UNITED STATES
NUCLEAR REGULATORY COMMISSION
WASHINGTON, D.C. 20555-0001

SUBJECT: MCGUIRE NUCLEAR STATION, UNITS 1 AND 2, ISSUANCE OF
AMENDMENT NOS. 326 AND 305, REGARDING CHANGES TO TECHNICAL
SPECIFICATION 3.4.3, REACTOR COOLANT SYSTEM PRESSURE AND
TEMPERATURE LIMITS (EPID L-2021-LLA-0232)

SAFETY EVALUATION BY THE OFFICE OF NUCLEAR REACTOR REGULATION
RELATED TO
AMENDMENT NO. 326 TO RENEWED FACILITY OPERATING LICENSE NO. NPF-9
AND AMENDMENT NO. 305 TO RENEWED FACILITY OPERATING LICENSE NO. NPF-17
DUKE ENERGY CAROLINAS, LLC
MCGUIRE NUCLEAR STATION, UNITS 1 AND 2
DOCKET NOS. 50-369 AND 50-370

Figure 3.4.3-2 McGuire Unit 1 Reactor Coolant System Heatup Limitations (Heatup Rates of 80 & 100°F/hr) Applicable for the First 54 EFPY (Without Margins for Instrumentation Errors) Using 1996 App.G Methodology & ASME Code Case N-641

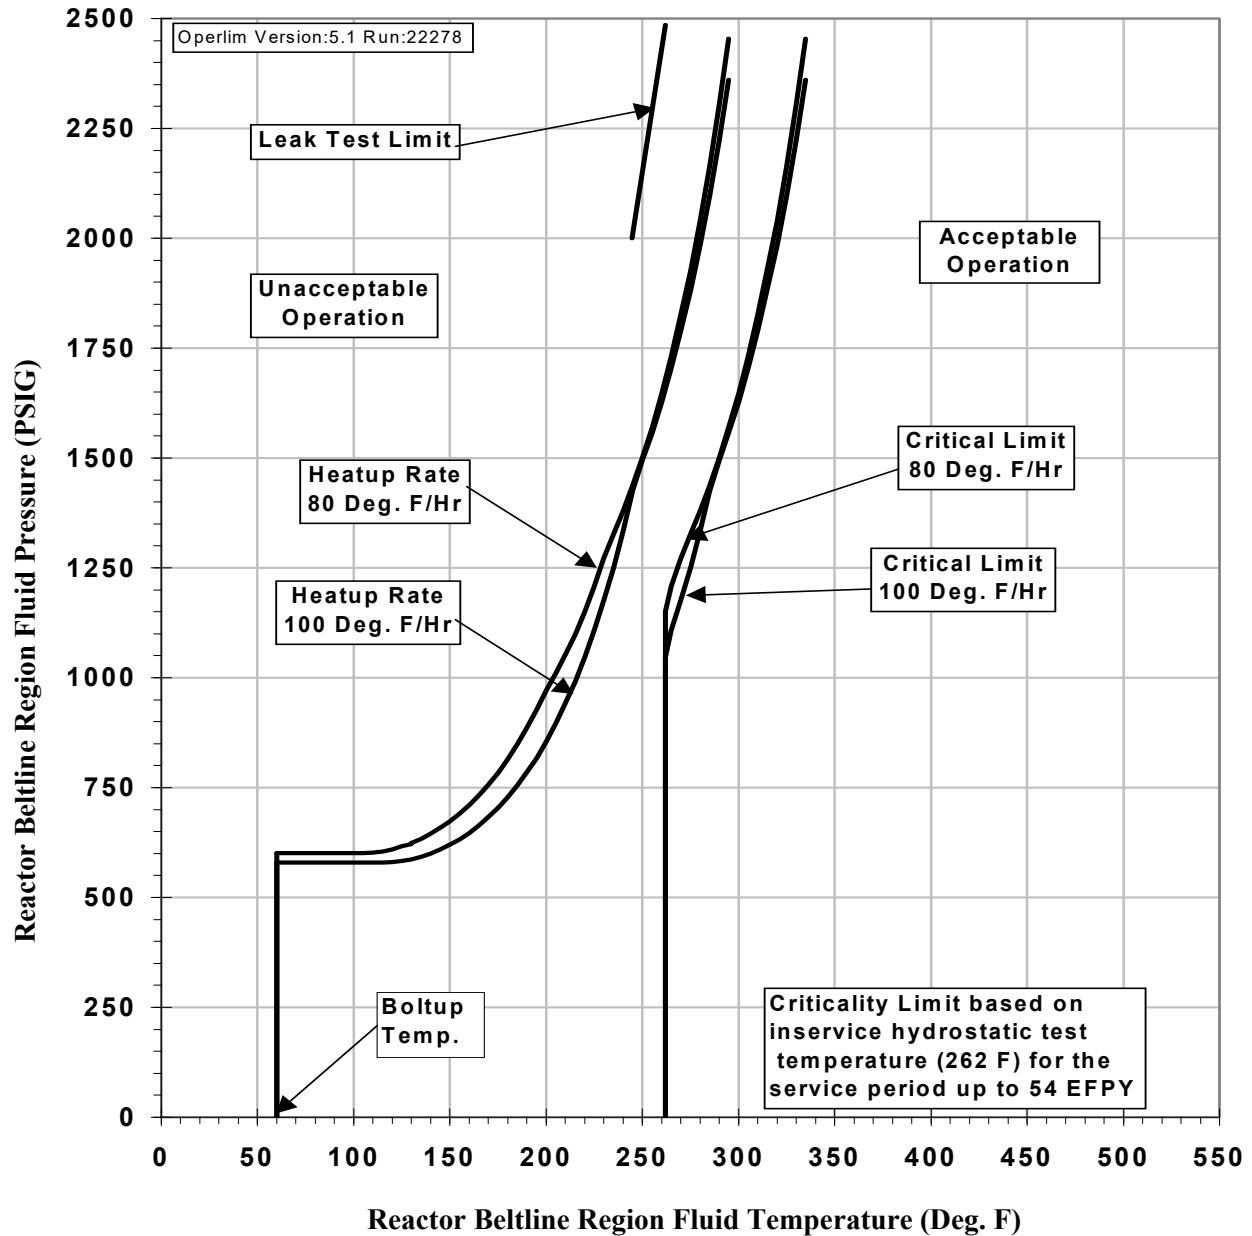
- TS Figure 3.4.3-2, "McGuire Unit 1 Reactor Coolant System Heatup Limitations (Heatup Rates of 80 & 100°F/hr) Applicable for the First 34 EFPY (Without Margins for Instrumentation Errors) Using 1996 App. G Methodology & ASME Code Case N-641," is revised to specify an applicability term of 54 EFPY.

- The statement in each Figure, “Limiting ART values at 34 EFPY,” revises the applicability term statement for the limiting ART values (i.e., Limiting ART values at 34 EFPY) to reflect 54 EFPY for Unit 1 and 38.6 EFPY for Unit 2.

- The proposed change revises the “Criticality Limit” note in Figures 3.4.3-1, 3.4.3-2, 3.4.3-3, and 3.4.3-4, stating that the “[c]riticality limit based on the inservice hydrostatic test temperature (262 F) for the service period up to 34 EFPY,” reflect an applicability period of 54 EFPY for Unit 1 and 38.6 EFPY for Unit 2.

LIMITING ART VALUES AT 54 EFPY: 1/4T, 202°F
 3/4T, 146°F

Figure 3.4.3-5 McGuire Unit 1 Reactor Coolant System Cooldown Limitations (Cooldown Rates up to 100°F/hr) Applicable for the First 54 EFPY (Without Margins for Instrumentation Errors) Using 1996 App.G Methodology & ASME Code Case N-641

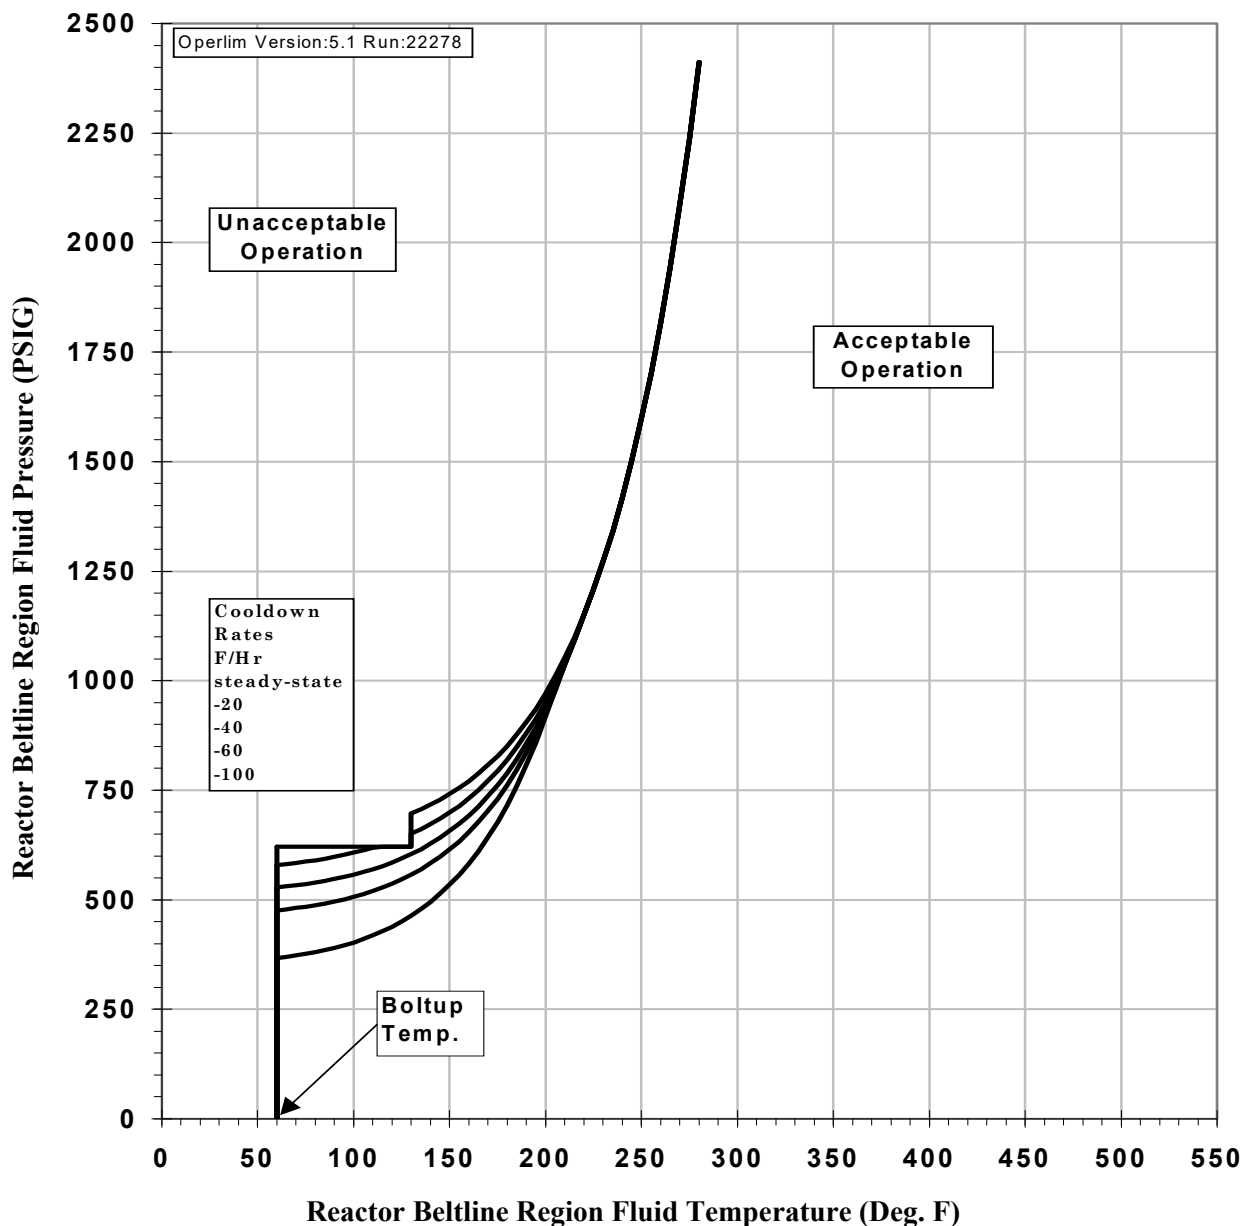
- TS Figure 3.4.3-5, “McGuire Unit 1 Reactor Coolant System Cooldown Limitations (Cooldown Rates up to 100°F/hr) Applicable for the First 34 EFPY (Without Margins for Instrumentation Errors) Using 1996 App. G Methodology & ASME Code Case N-641,” is revised to specify an applicability term of 54 EFPY.

LIMITING ART VALUES AT 54 EFPY: 1/4T, 202°F
 3/4T, 146°F
